HOLLEY BRANCH

RESUBDIVISION OF LOTS 29, 30, 31

APPLICATION NUMBER 9 DATE December 20, 2007

DETAIL SITE PLAN

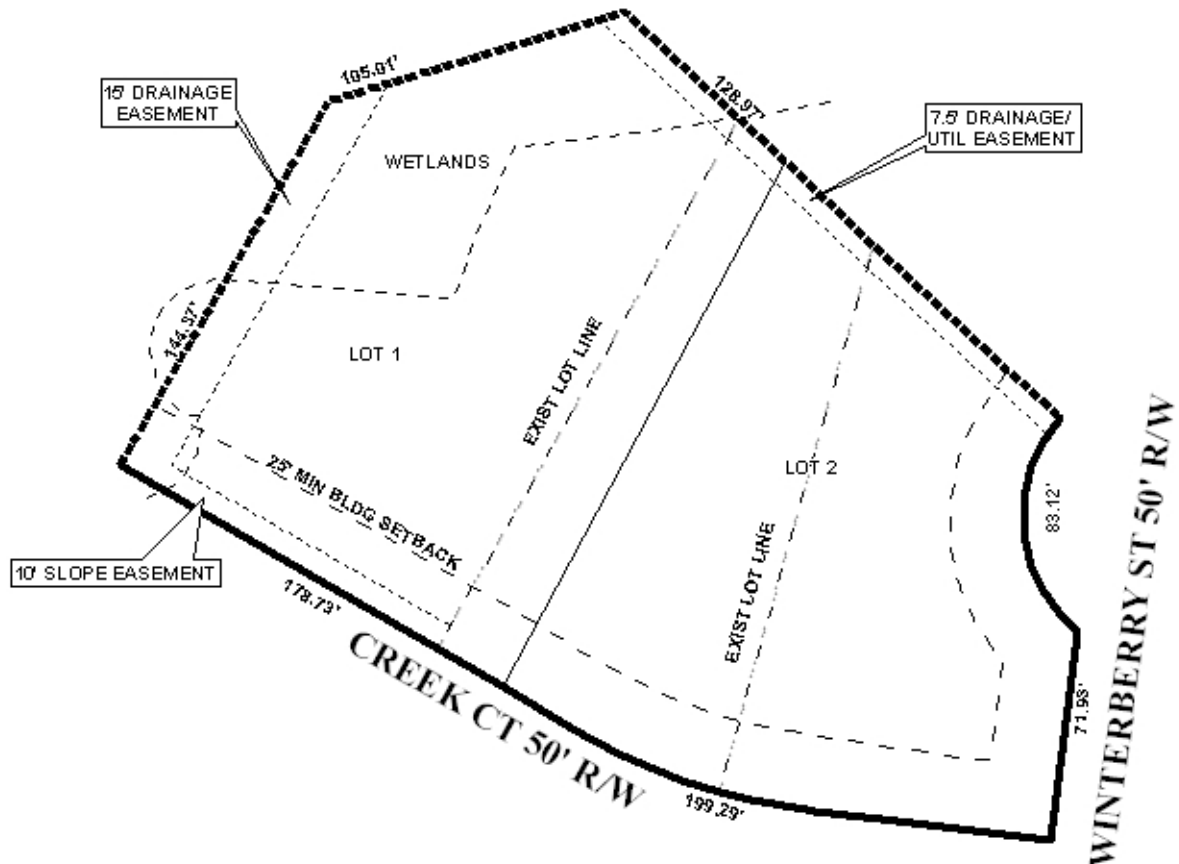
As Lot 1 has approximately 151' of frontage along Creek Court, it should be limited to one curb cut. Lot 2 is a corner lot with frontage along Creek Court and Winterberry Street. Since it is residential property, it should also be limited to one curb cut. Furthermore, a sufficient radius on the corner of Creek Court and Winterberry Street should be provided, compliant with Section V.B.16. of the Subdivision Regulations.

As illustrated on the preliminary plat, the site contains wetlands. Thus, the area could be environmentally sensitive. The applicant must obtain any necessary federal, state, and local environmental approvals.

- 1) placement of a note stating that each lot is limited to one curb cut, with the size, location, and design to be approved by Traffic Engineering and conform to AASHTO standards;

- 2) provision of a sufficient radius on the corner of Creek Court and Winterberry Street, compliant with Section V.B.16. of the Subdivision Regulations;

- 3) the applicant obtain any necessary federal, state, and local environmental approvals;
- 4) placement of a note on the final plat stating that any lots developed commercially and adjoin residentially developed property shall provide a buffer in compliance with Section V.A.7. of the Subdivision Regulations; and
